RE: Gold Hill Mill, Permit No. M-1994-117

**Technical Revision 11 – Times/Wynona Mine Bulkhead Design
Adequacy Response**

TECHNICAL MEMORANDUM

TO:	Jerry Jergensen	DATE:	11/8/2022
COMPANY:	Colorado Milling Company, LLC	SUBJECT:	Time Mine Bulkhead Design Calculations
ADDRESS:	50 West 100 South Street Moab, Utah 80342	PROJECT NAME/NO.:	22690002.000
FROM:	Christoph Goss, PhD, PE	CC:	Ben Langenfeld

Bulkhead Location Map

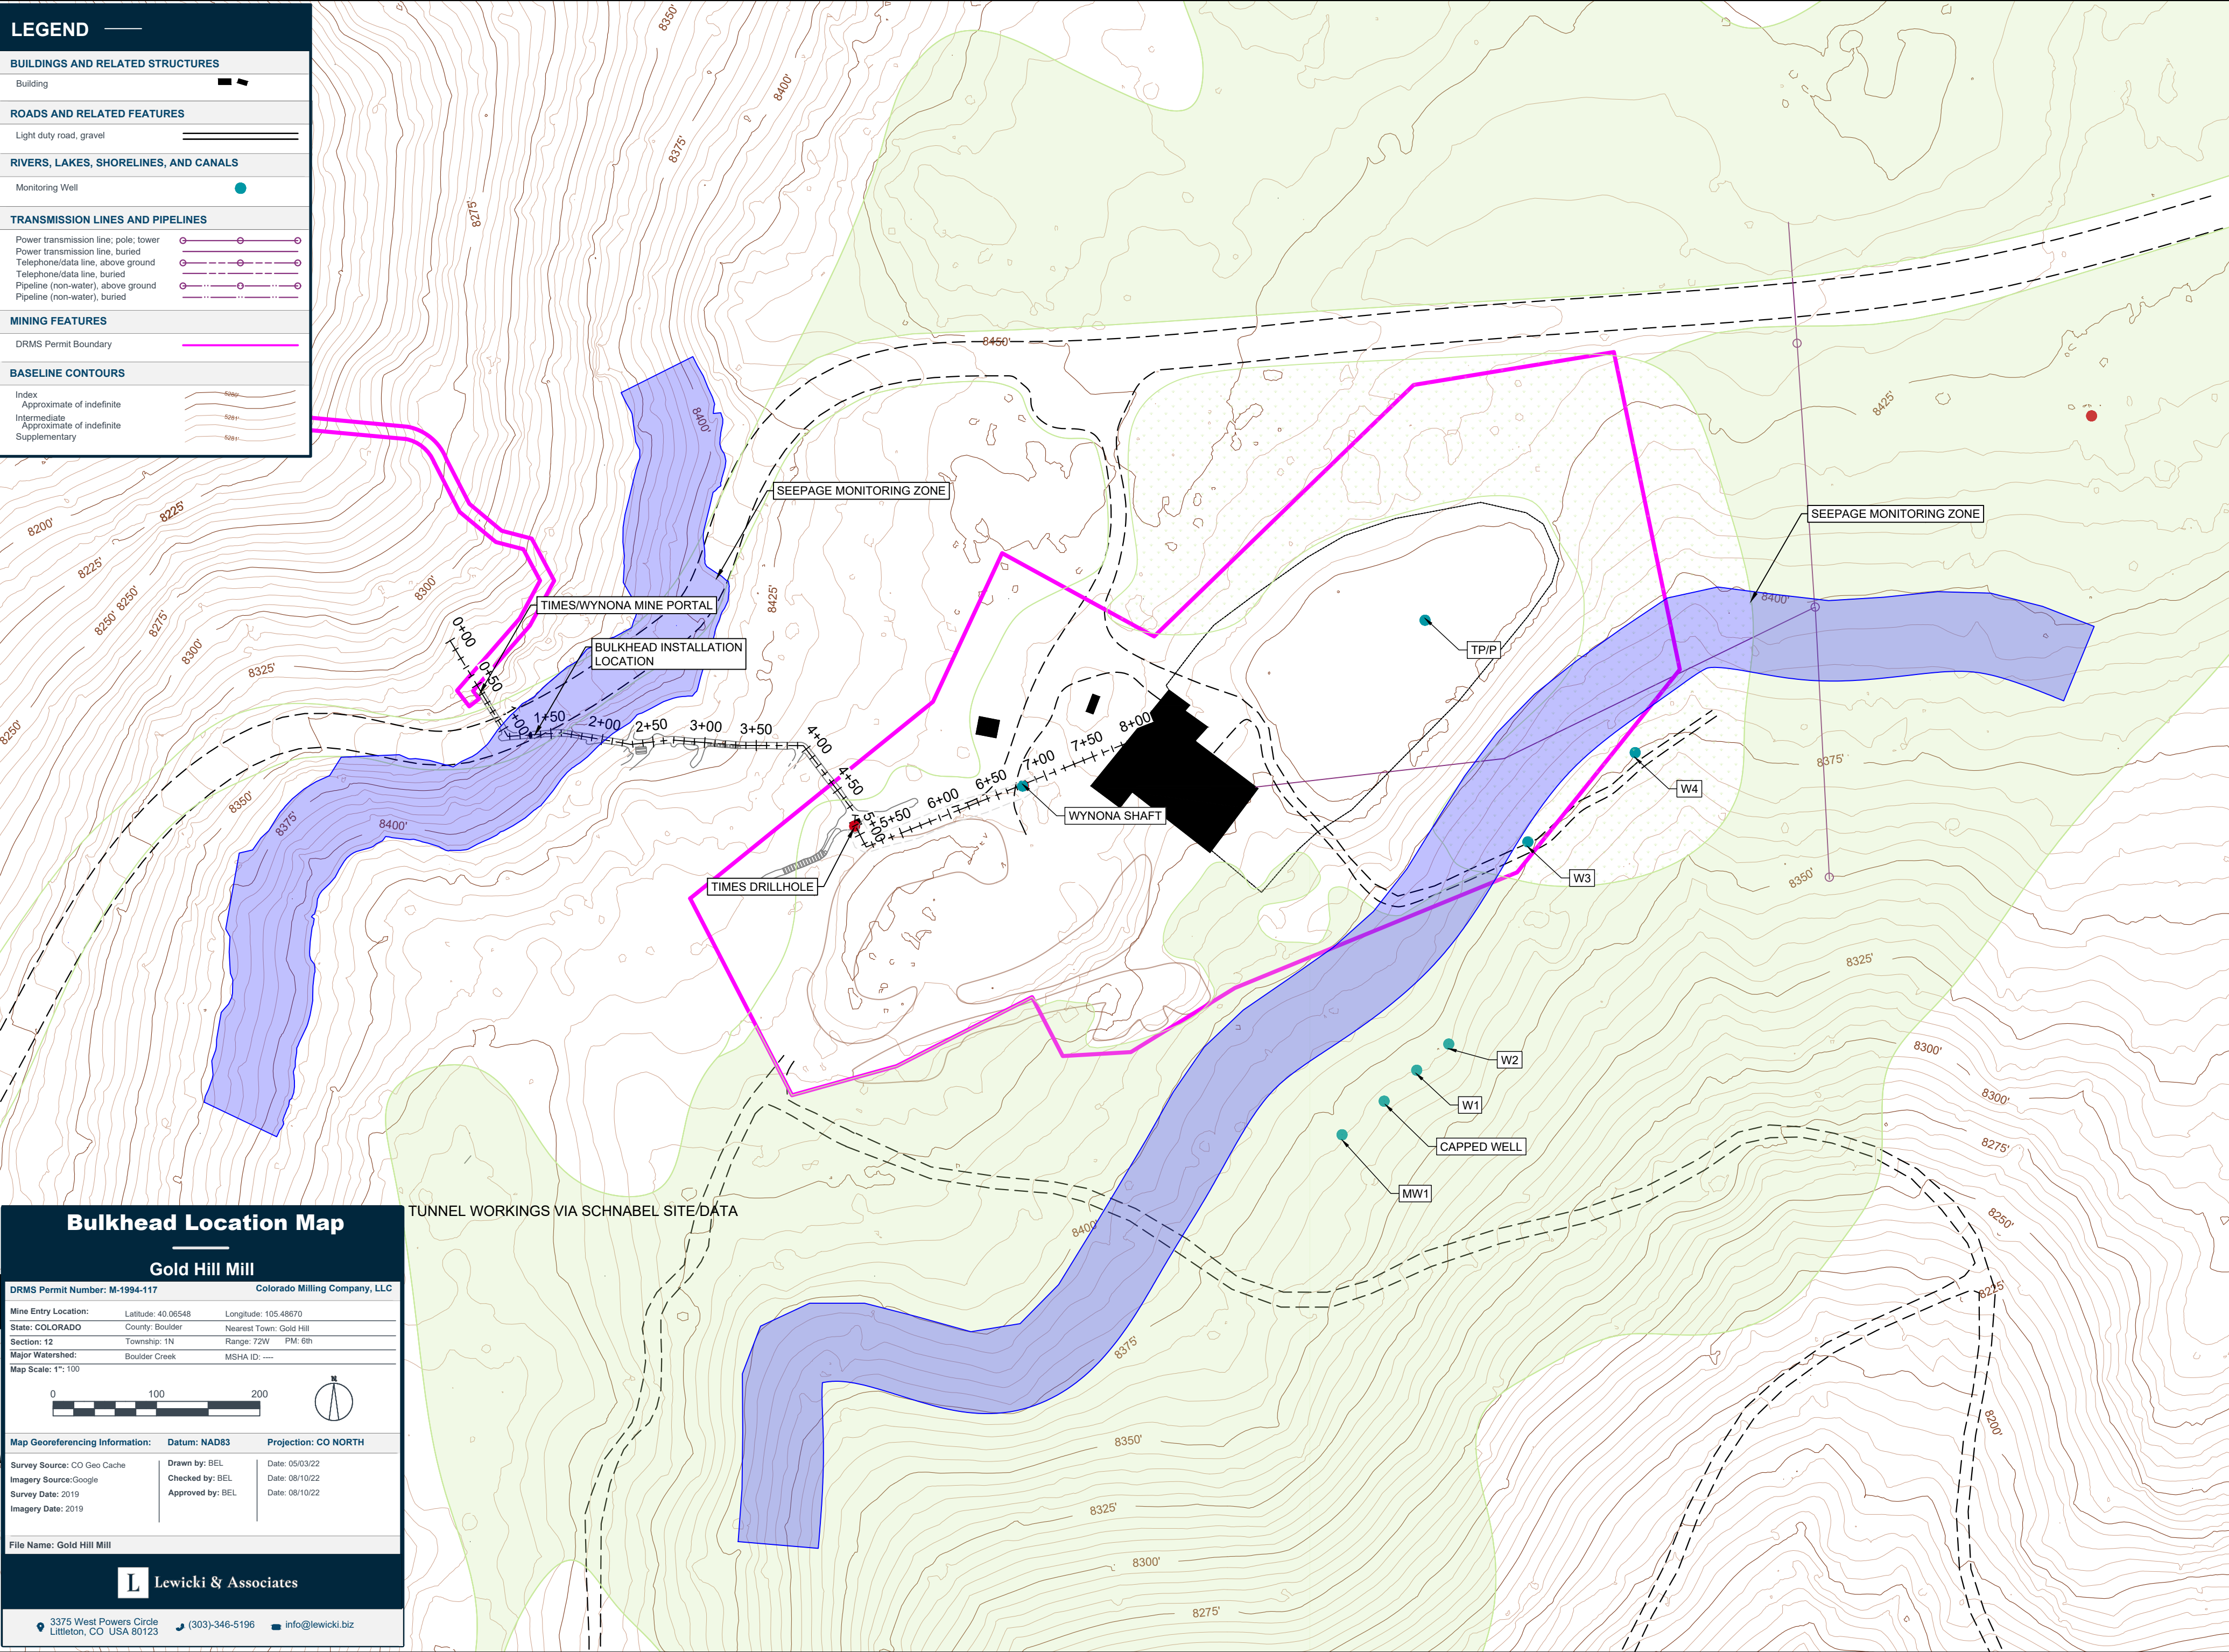
Monitoring Plan Comments

Colorado Milling Company will monitor along both sides of the ridge (east and west) from the Times-Winona Adit (8340') up for seeps and springs. General monitoring areas are shown on the attached Bulkhead Location Map. Groundwater levels in existing monitoring wells will be measured during bulkhead filling. The 90-day monitoring period will begin upon bulkhead filling.
